Subject: Material for today's Light-duty GHG NPRM discussion.

Summary points from EPA review of CAFE model (NPRM version) – Effect of EPA code revisions

Meeting with Office of Management and Budget/OIRA

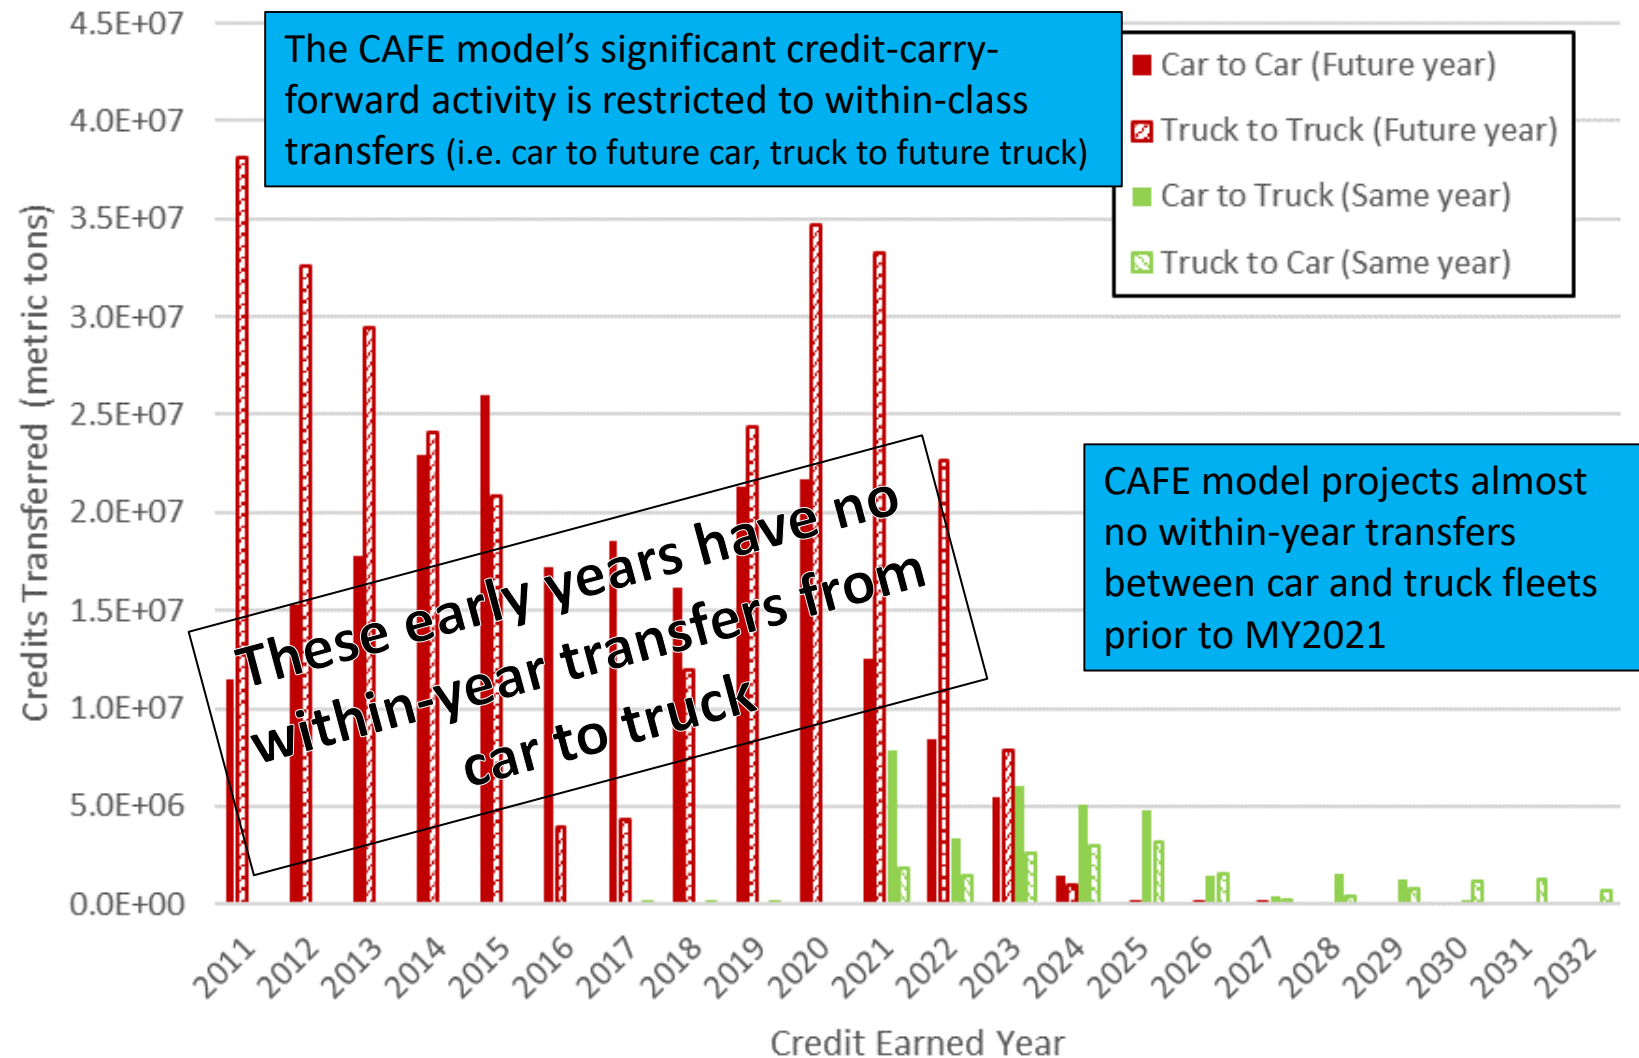
Real-world : Manufacturers will manage their credit banks to even out compliance status given staggered introduction of technology. It is unlikely that manufactures will consistently add excess technology in the earlier years in order to maintain a large credit bank into the future.

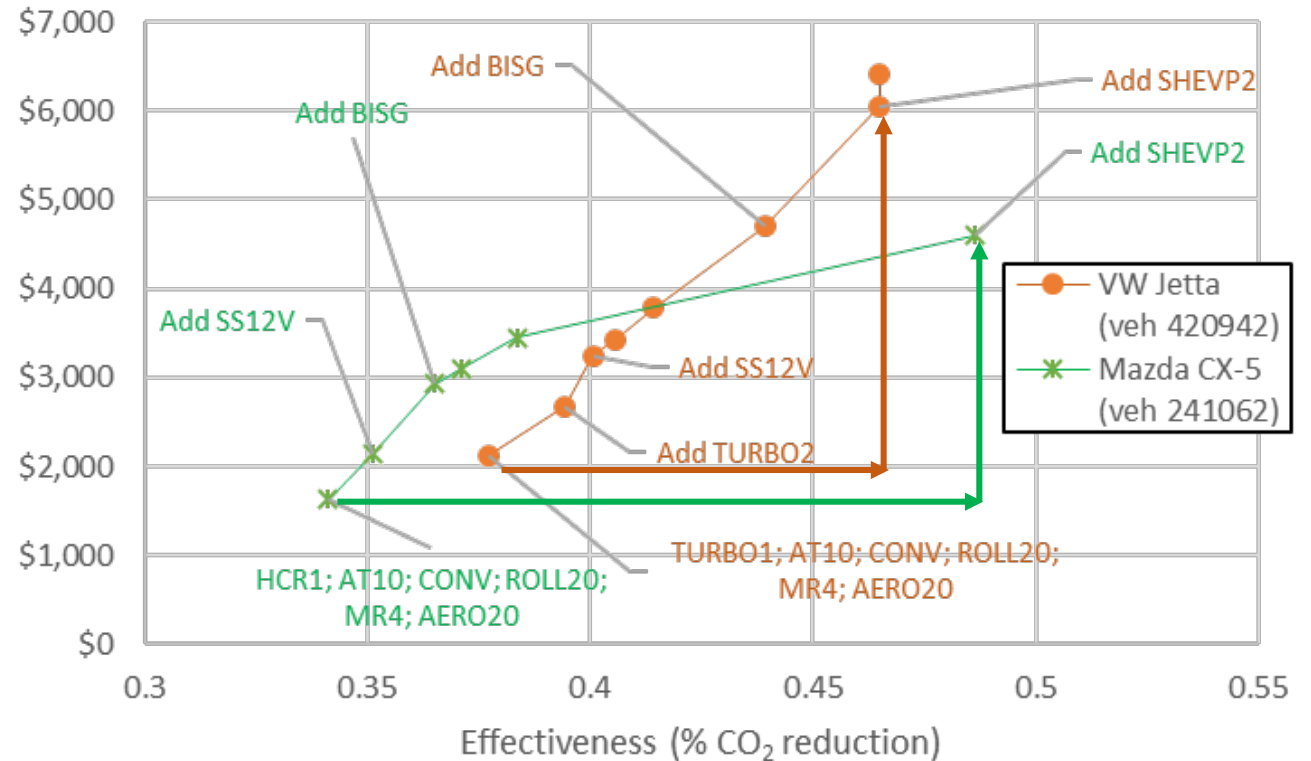
Real-world: The effectiveness benefits of strong hybridization (P2HEV and PSHEV) is dependent on the base engine technology to which the technology is applied. In typical applications, manufacturers will pair strong hybridization with efficient, but low cost Atkinson cycle engines.

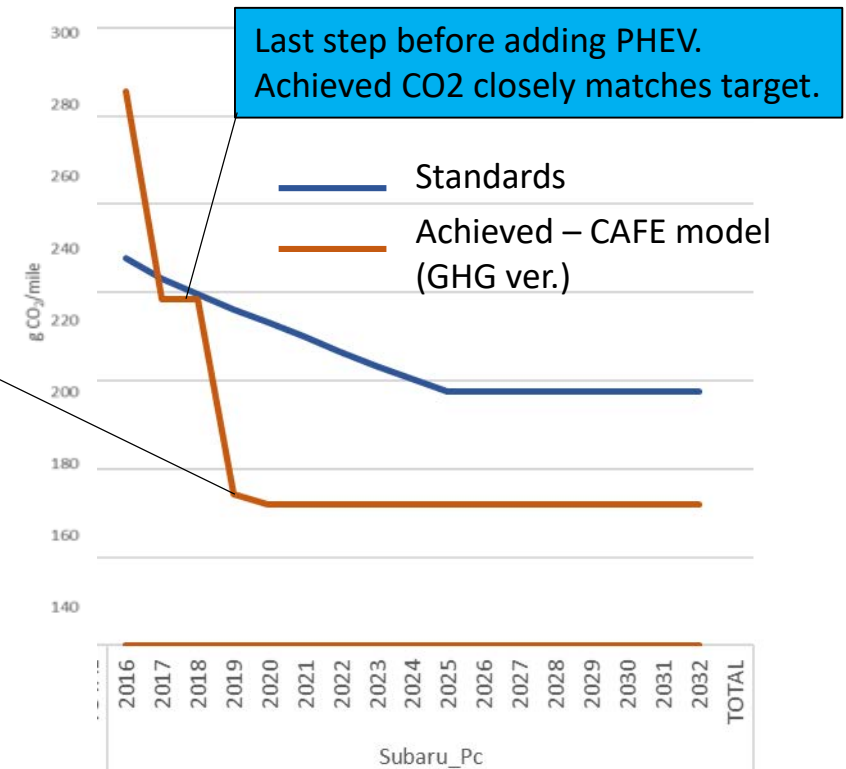
PHEV added to entire volume of fleet, resulting in significant overcompliance

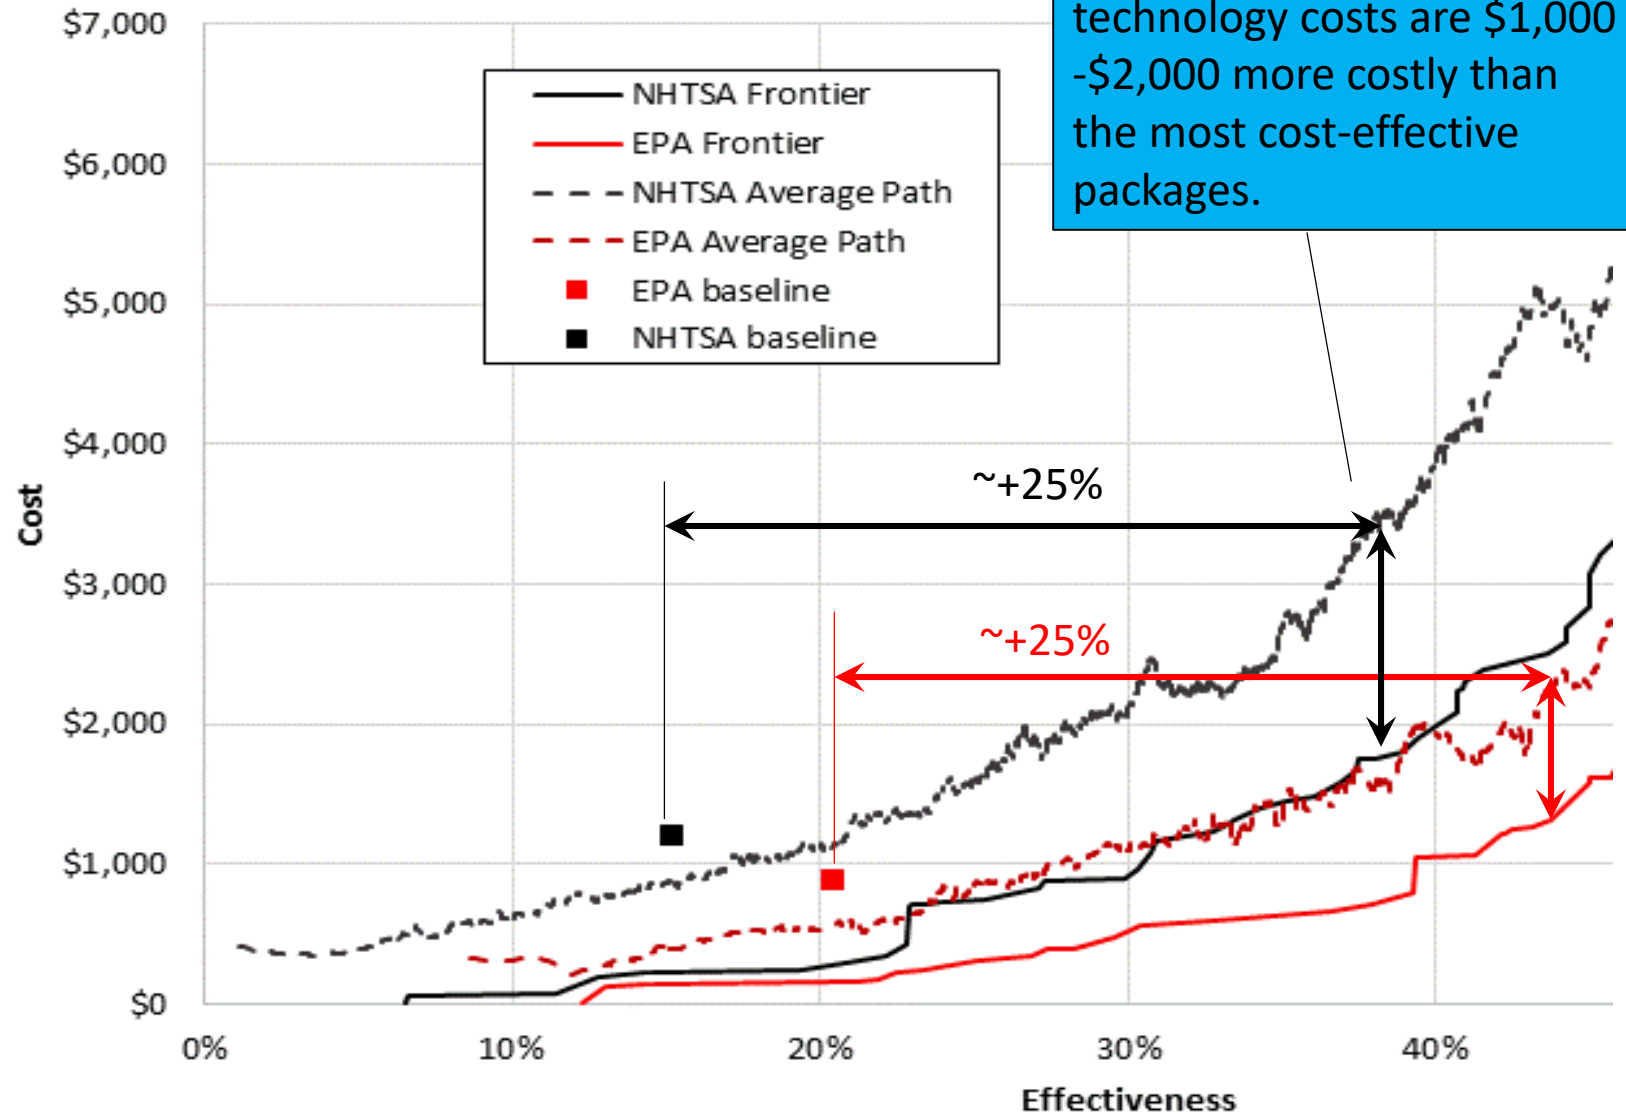
Average CAFE model technology costs are \$1,000-\$2,000 more costly than the most cost-effective packages.
